# ADA Curb Ramp New Construction Inspection Form (Perpendicular)

Nw 292nd

23885.56

Nw Keenon

## PERPENDICULAR RAMP (PR)

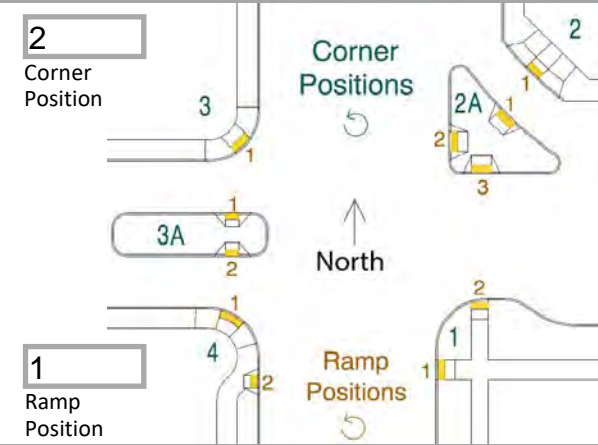
Slope Y

2.9

■

TS VL greater than 1/4"
